Development Engineering Formal Referral Response

Application Information	
Referral Officer	Lara Fiscalini
Officer	Mark Pisani
Council Reference	IREF22/00739
Address	1-9 Doonside Street, Richmond
Application No.	PPE22/0103
Proposal	Referral - Internal – Development Engineering
Comments Sought	Victoria Gardens expansion

Vehicle Crossing – Cross Section

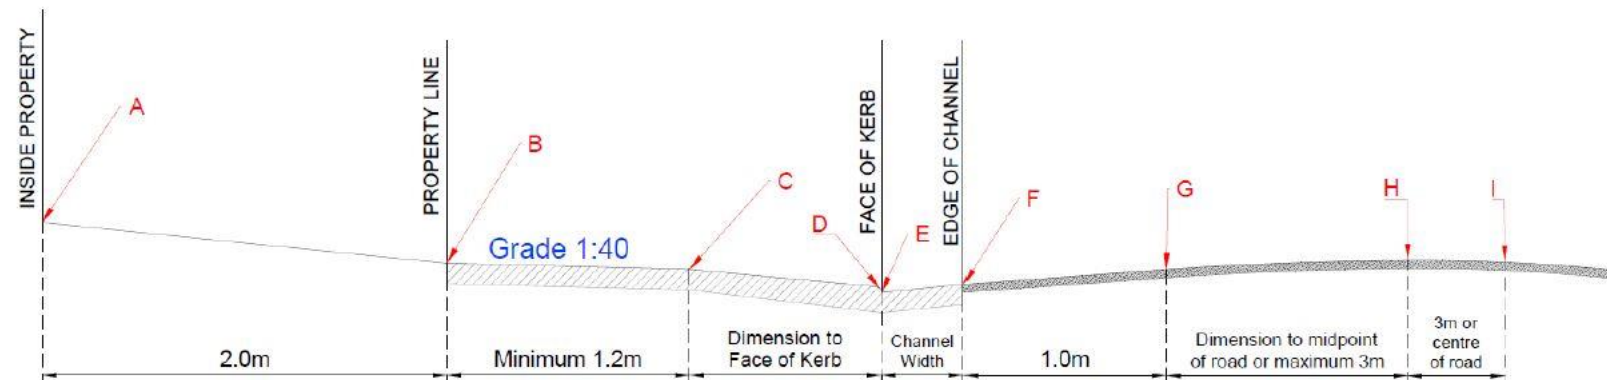
The designer is to submit a 1:20 scale cross section for each proposed vehicle crossing showing the following items:

| A. Finished floor level 2.0 metres inside property | E. Surface level at the bottom of the kerb |
| B. Property line surface level | F. Surface level at the edge of channel |
| C. Surface level at change in grade (if applicable) | G. Road level 1.0 meter from the edge of channel |
| D. Bullnose (max height 60mm) – must be clearly labelled | H., I. Road levels |

- Please note the cross section must be fully dimensioned. As shown in the sketch below.
- Please show both the existing and proposed surface.
- The maximum allowable cross-fall between points B and C is 1:40 (2.5%).
- A bullnose (max 60mm) is permitted at point D, however not compulsory.
- The levels shown must be exact reduced levels, to three decimal points. Interpolation of levels is not acceptable.
- The designer must demonstrate that an 85th or 99th percentile vehicle profile can traverse the design cross section as per the Australian/New Zealand Standard ground clearance template (AS/NZS 2890.1:2004).
- Significant level changes to the existing footpath level B to C will require additional level design either side of the proposed crossing.
- Please include any additional levels or changes in grade that are not shown in the diagram.
